STAFF RECOMMENDATION
3620 Westbrook Avenue
December 19, 2012

Application: New construction - addition
District: Richland-West End Neighborhood Conservation Zoning Overlay
Council District: 24
Map and Parcel Number: 10405021800
Applicant: Betsy Bergin, Architect
Project Lead: Sean Alexander, sean.alexander@nashville.gov

FRONT ELEVATION

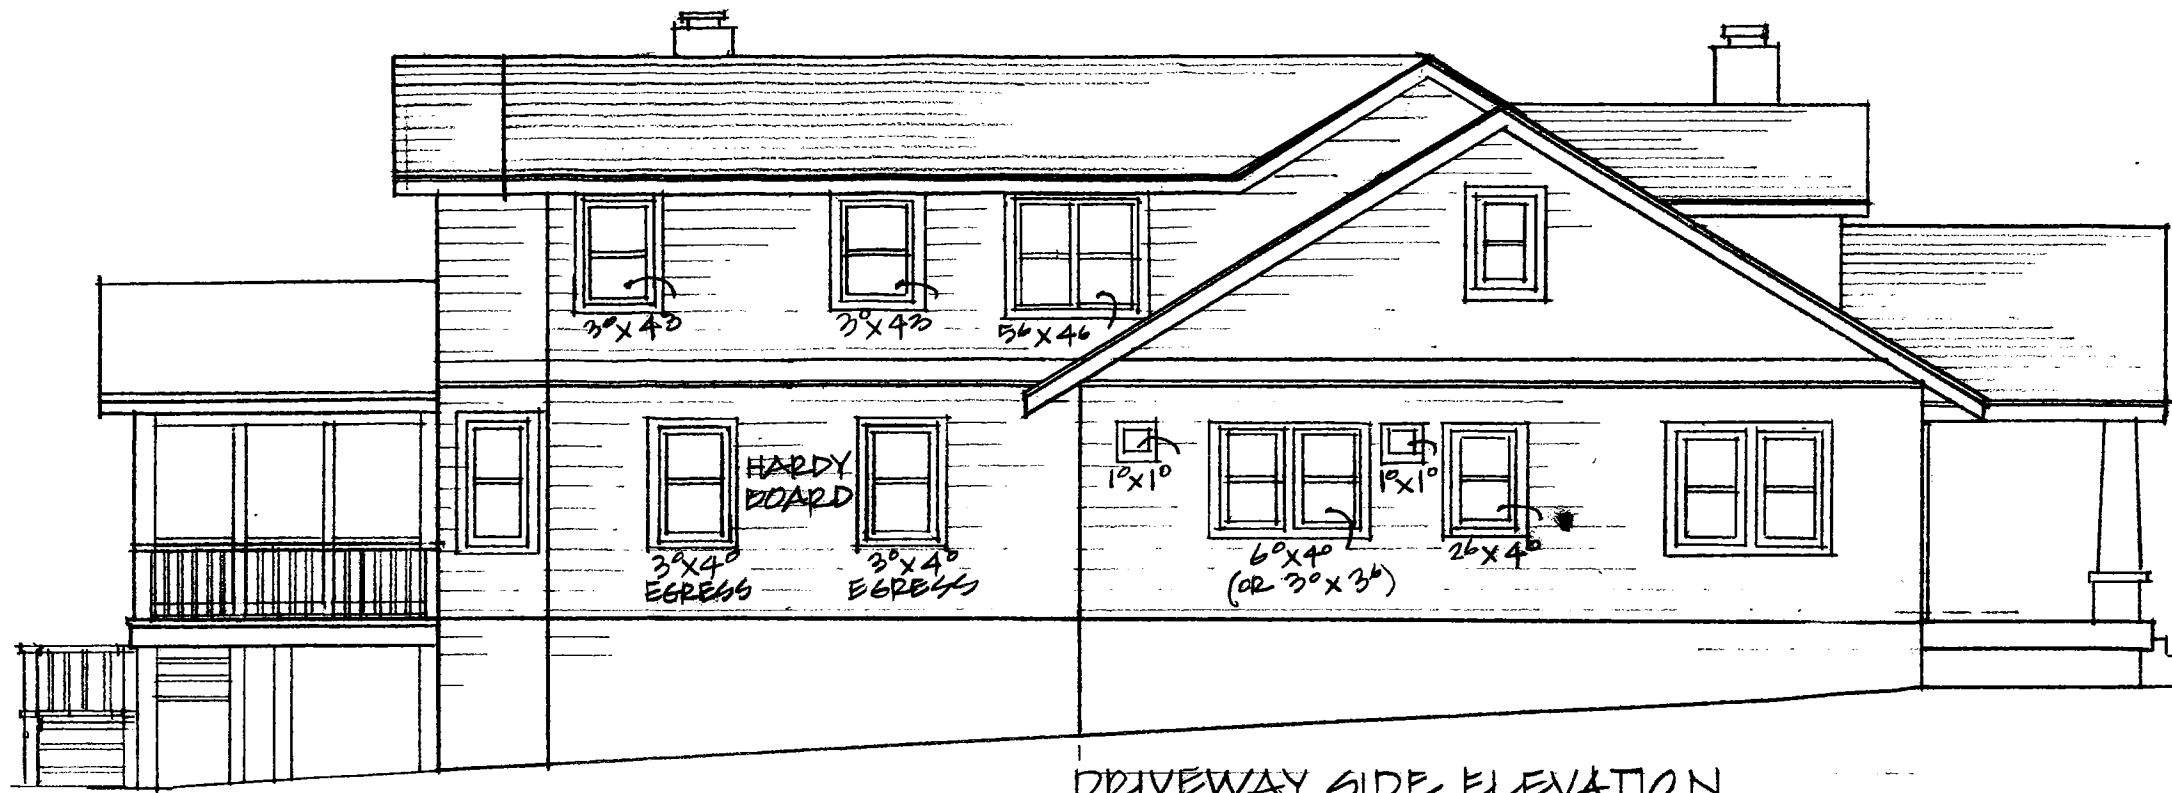
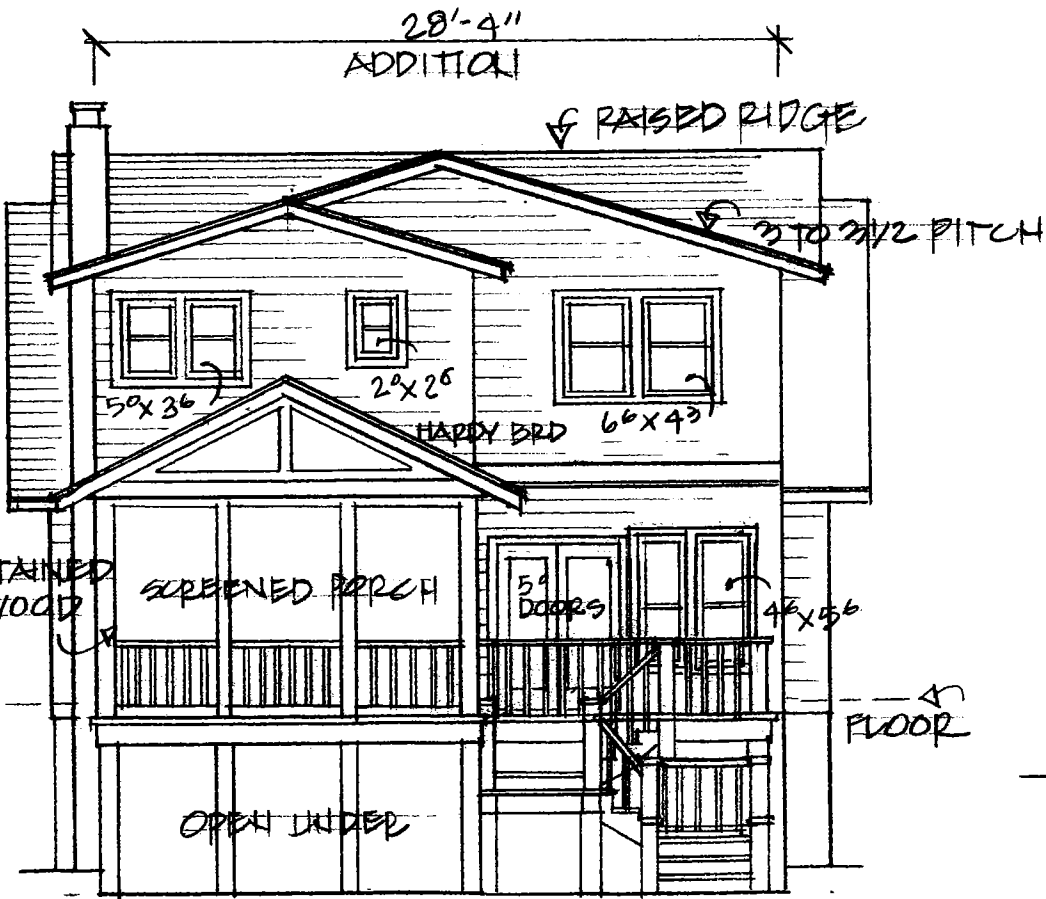
The front slope of the existing roof will be extended up and toward the rear raising the ridge two feet (2') higher, leaving two feet (2') of the existing ridge unaltered on each side of the house. This type of addition has been found by the Commission to be appropriate for side-gabled houses.

A two-story rear addition will be constructed with the side walls setting in two feet (2') from the sides of the house on each side, with a gabled roof intersecting the raised ridge at a "T."

The addition will extend twenty-two feet (22') to the rear on the left side, and twenty-six feet, six inches (26'-6") on the right, which will be subordinate to the historic house. The house is forty-five feet (45') deep, including the front porch. A one story screened porch will further extend the length of the addition twelve-feet, nine inches (12'-9") along the right side. The foundation height and floor levels of the addition will match those of the historic house. Because the addition sets in from the sides of the historic house and will be no taller than the raised ridge, it will not disturb the form of the historic house and will not have a significant impact on its appearance from the right of way. Staff finds the height and scale of the addition to meet guidelines II.B.1.a. and II.B.1.b.

Staff recommends approval of the ridge raise and rear addition, finding it to meet the guidelines for new construction and additions in the Richland-West End Neighborhood Conservation Zoning Overlay.

REAR ELEVATION

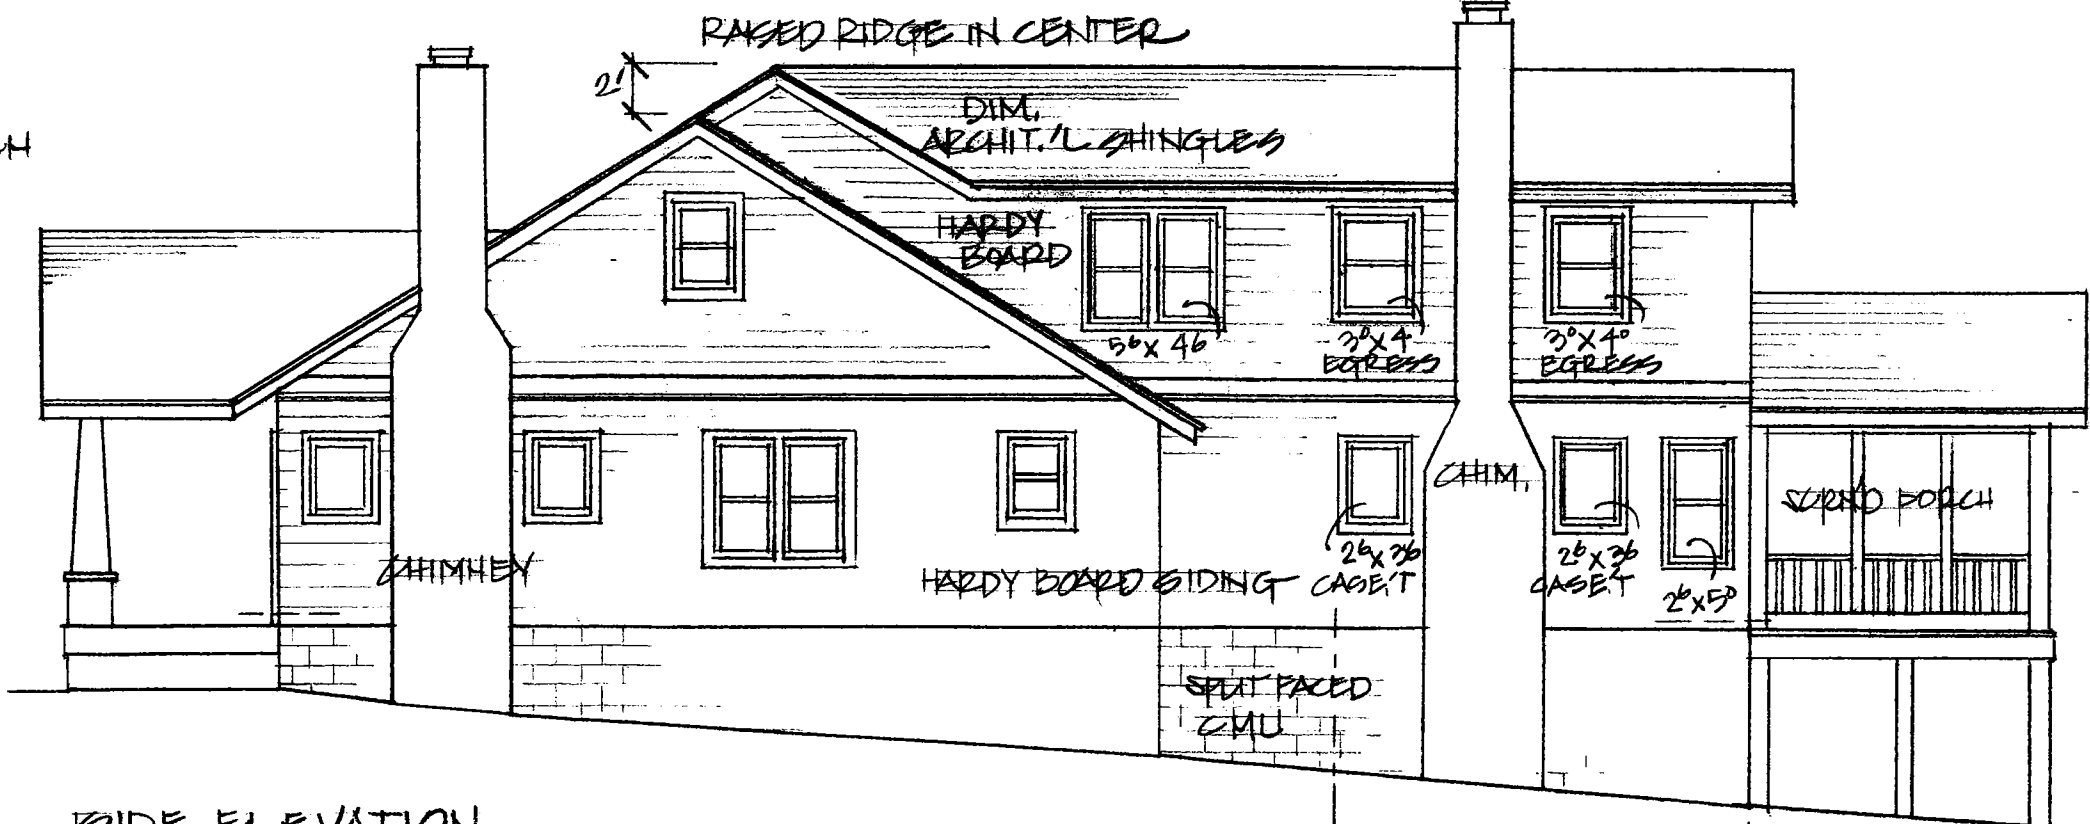
The exterior of the addition will be clad with smooth-faced cement-fiber siding matching the exposure of the siding on the house. The windows, window casings, and other trim will be wood. The foundation will be split-faced concrete block and the roof will be gray composite shingles. There will be a brick chimney on the left side, matching a brick chimney on the historic house. Staff finds these materials to be compatible with those of the house and to meet guideline II.B.1.d.

The window patterns on the sides of the addition will maintain the rhythm of openings on the historic house, with windows compatible in proportion to those on the house as well. The addition will meet guideline II.B.1.g.
